Project	IEEE 802.16 Broadband Wireless Access Working Group < http://ieee802.org/16 >	
Title	Solutions for some AIs in last meeting.	
Date Submitted	2007-03-15	
Source(s)	Wu Xuyong, Huawei	Voice: +86-755-28973547 Fax: wuxuyong@huawei.com ,
Re:	IEEE 802.16-07/010: IEEE 802.16 Working Group Letter Ballot Recirc #24a: Announcement (2007-02-01)	
Abstract	Following AIs assigned in last meeting.	
Purpose	To consolidate the 16h draft.	
Notice	This document has been prepared to assist IEEE 802.16. It is offered as a basis for discussion and is not binding on the contributing individual(s) or organization(s). The material in this document is subject to change in form and content after further study. The contributor(s) reserve(s) the right to add, amend or withdraw material contained herein.	
Release	The contributor grants a free, irrevocable license to the IEEE to incorporate material contained in this contribution, and any modifications thereof, in the creation of an IEEE Standards publication; to copyright in the IEEE's name any IEEE Standards publication even though it may include portions of this contribution; and at the IEEE's sole discretion to permit others to reproduce in whole or i

531a) change figure h46 as follows(only to move the shared part to the front of the 4 frame.):

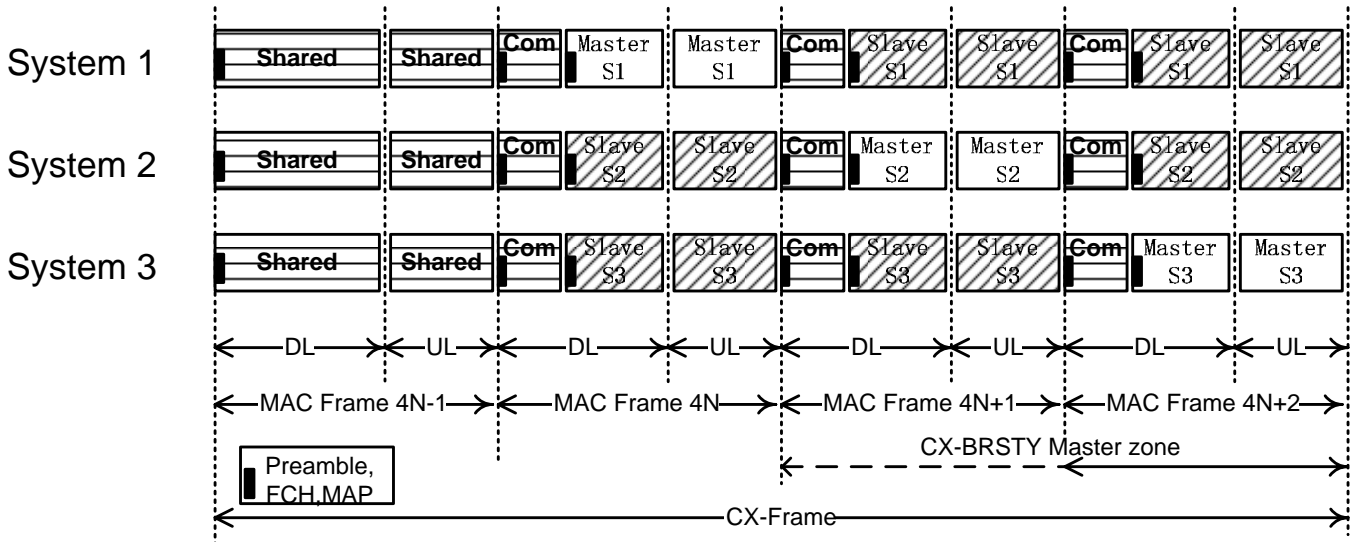
Comment: [531] By Phillip Barber

What if a BS is a part of more than one neighborhood or community? part of three neighborhoods? four? nine? How can the available solution methodologies cope with the complexity of such decision making?

Discussion: There is some discussion within Mariana's AIs, and some reply is relating to this topic, by the proposal of following frame structure, we limited only up to 3 systems within the neighborhood to share the radio resource in one channel.

Resolution: *We have limit the number of subframes to three in one working channel to allow the coexistence within neighborhood.*
